TO: Board of Zoning Adjustment

Date: May 14, 2020

RE: Comments in Opposition: Case Number 20290, Application of Vitis Investments LLC

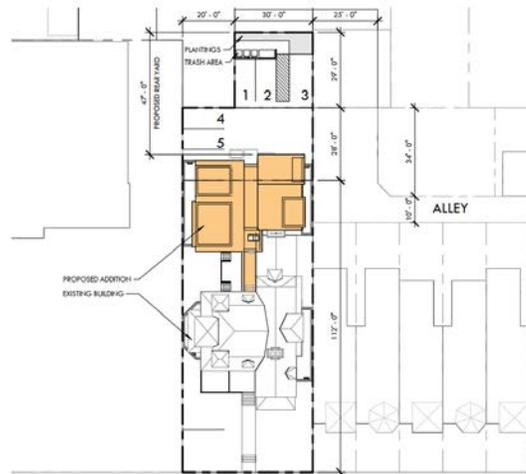
C § 701.5 requires that multi-unit residential buildings in an R or RF zone have at least 1 parking space per 2 dwelling units. The 11 units in the proposed project would therefore require 6 parking spaces to be code compliant.⁵

As indicated by the underlined language, the reduction does not apply to R or RF zones. Accordingly, 6 parking spaces are required, meaning the 5 spaces proposed by Applicant are insufficient.

While the difference of only one parking space may not *seem* like a large problem, a review of Applicant's proposed development illustrates a significant issue. Stated simply: there does not appear to be any room for the required sixth parking space. Applicant's proposed plans (reproduced below) show that five spots are tightly placed into the alley Lot 805 and Lot 807 without room for any additional parking spaces.

Applicant's plans provide for only one parking space that is 9' wide by 18' long and 4 spaces that are 8' wide by 18' long. Accordingly, the Applicant is short 2 full-sized parking spaces. Additionally, three of the parking spaces on the Applicant's plans are served by a drive aisle that is only 16' wide, which is 4' narrower than permitted by the Zoning Regulations.

EXHIBIT B -Assessment and Taxation Plat - 410 U St NW

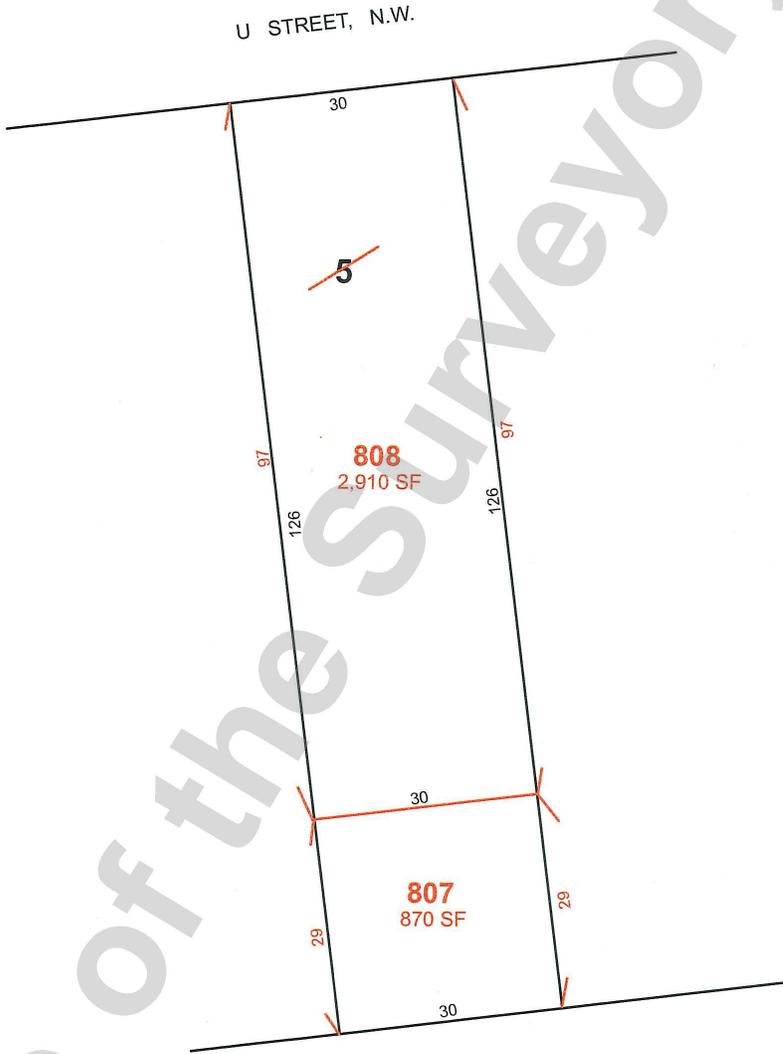
Lot 807 was only created by the Office of the Surveyor in October of 2019 despite having been conveyed to the previous owner of Lots 804 and 805 in 1996.² This lot was carved out of the back of the record lot at 410 U Street NW, as shown on the assessment and taxation plat attached to this letter as Exhibit B. As can be seen on the map attached here as Exhibit A, this conveyance broke the rear continuity of the lots on the south side of the 400 block of U Street NW and created a peninsula around the backyard at 412 U Street NW, effectively making Lot 807 an encroachment.

Lot 807 is an outlier, geographically and architecturally dissimilar to the lots around it, and an argument can be made that it should never have been conveyed to the previous owner of the Subject Property. Further, its small dimensions make it unsuitable for improvements – being only 29 x 30 feet in area, set back rules are virtually impossible to meet. The Applicant’s plans show Lot 807 being used as three parking spaces – meaning combining Lot 807 with Lots 804 and 805 is effectively a transfer of development rights to those lots. The potential problems created by Lot 807 can be minimized by keeping it a separate record lot from Lots 804 and 805.

EXHIBIT C - Photo Renderings of Proposed Addition

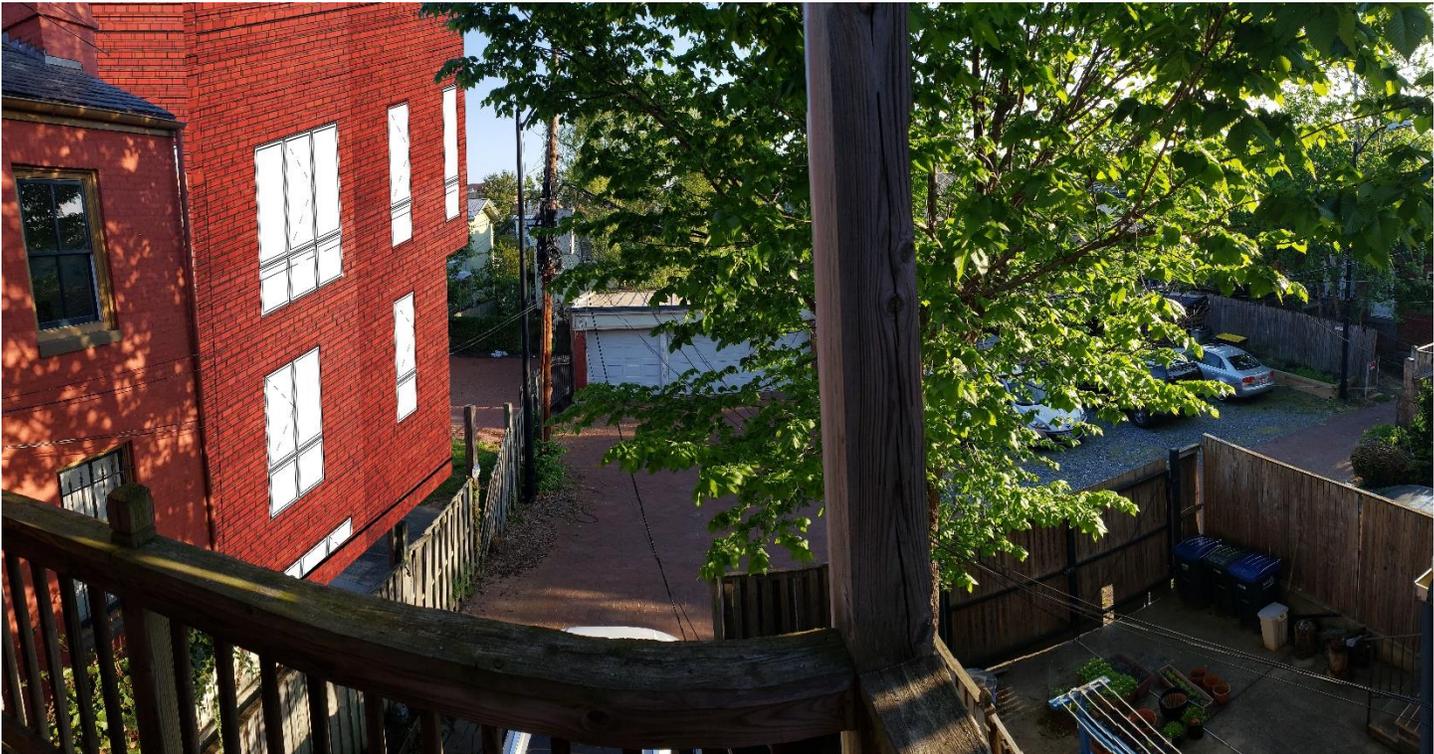
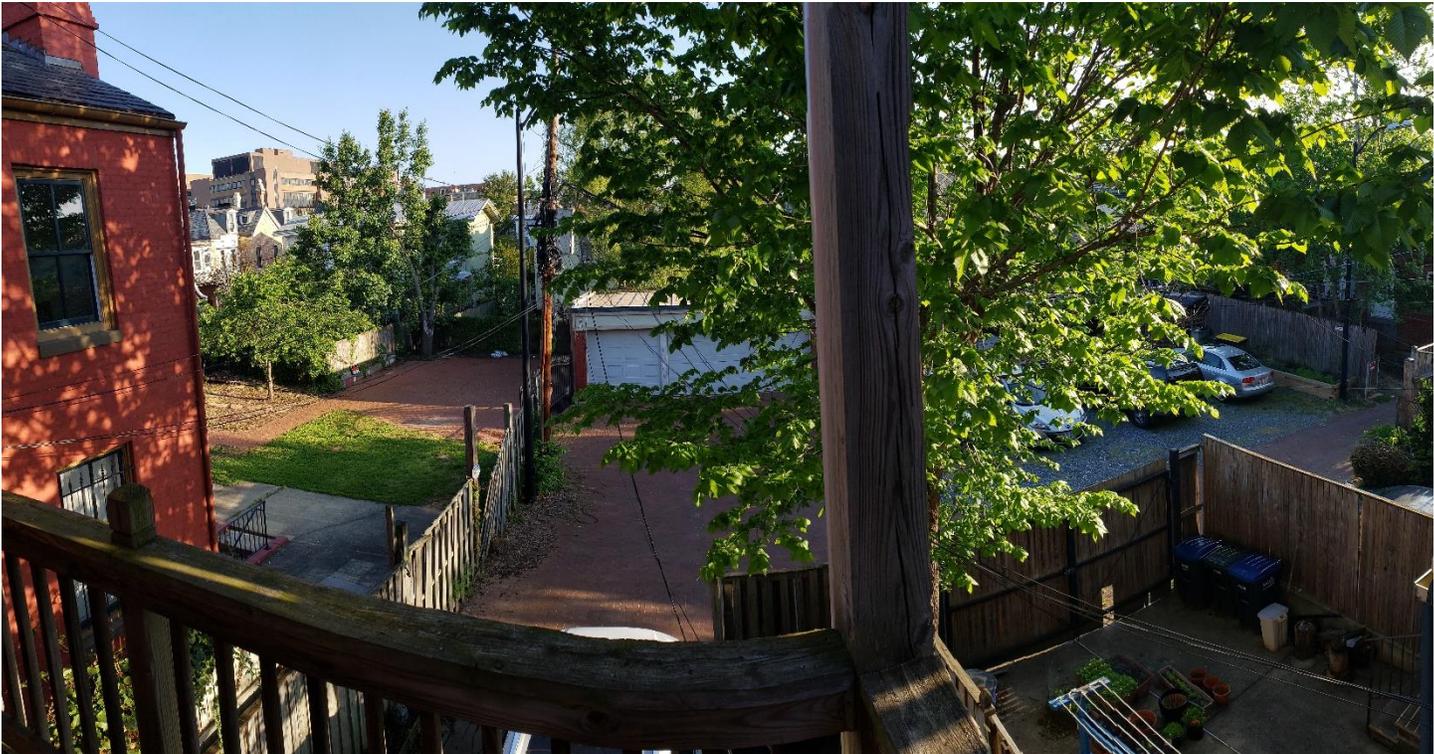
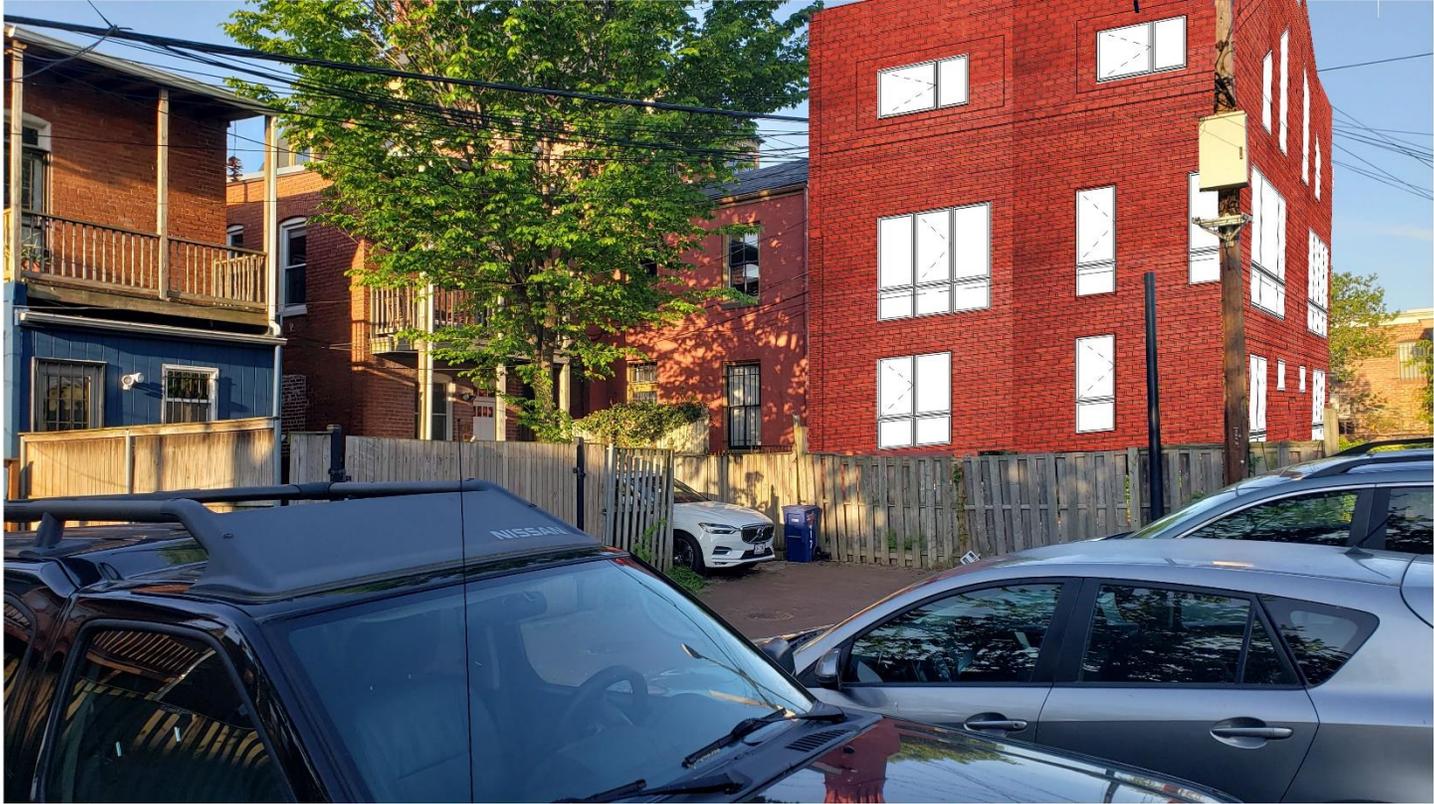
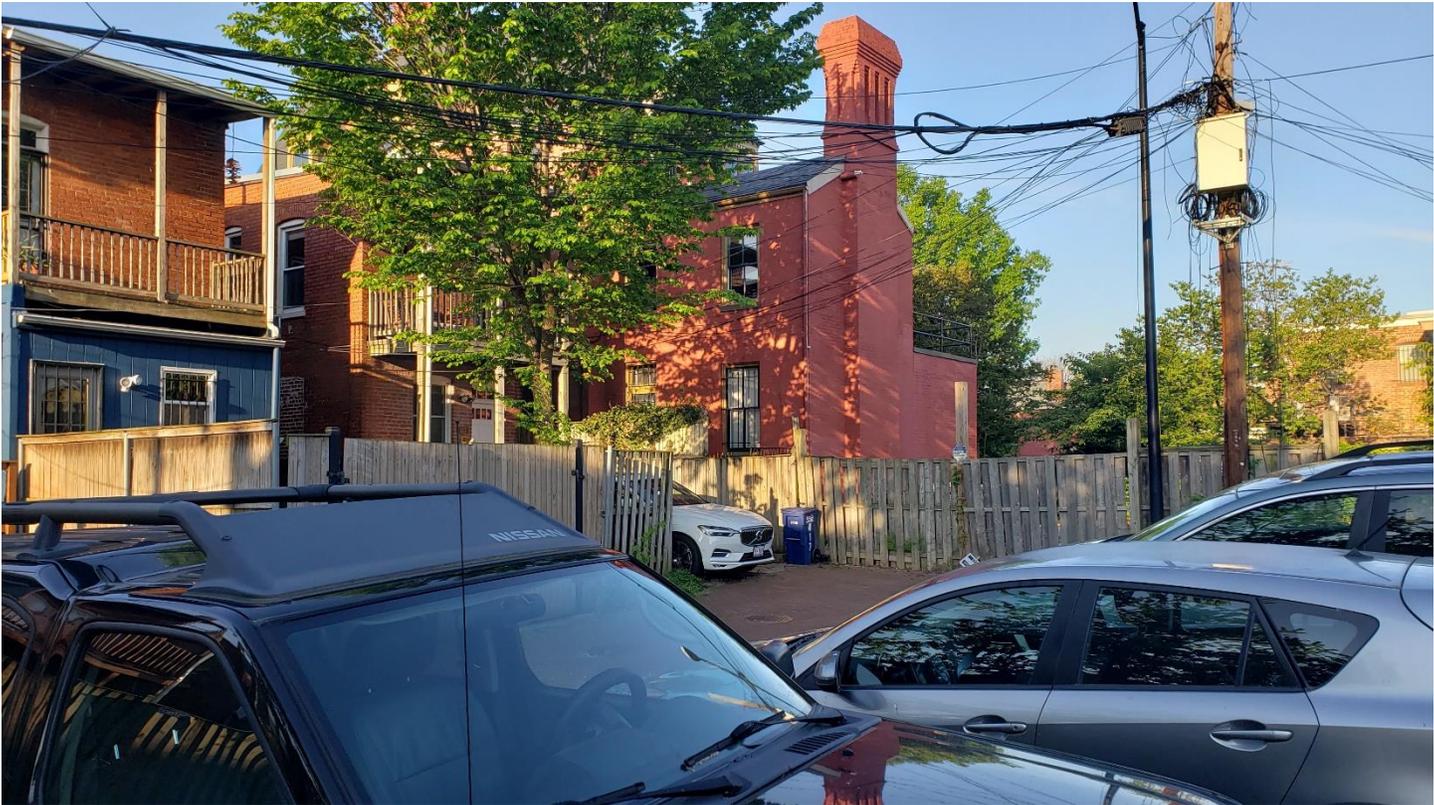
In an attempt to illustrate the impact that the proposed addition will have on what little outdoor space we have, we have created a few images to show the proposed addition in a more realistic setting, attached as Exhibit C. As one can see, the attached renderings show that the

proposed addition has a much greater impact than what is shown in the Applicant's renderings. We are sincerely concerned that the use of what little outdoor space we have will be essentially eliminated by the proposed addition. Moreover, the renderings in Exhibit C illustrate the impact on light and air that the proposed development would have not only on ourselves, but on our neighbors to the north, south, east, and west (as shown in pictures from the alleyway, from neighboring houses, and from 4th Street NW as well).
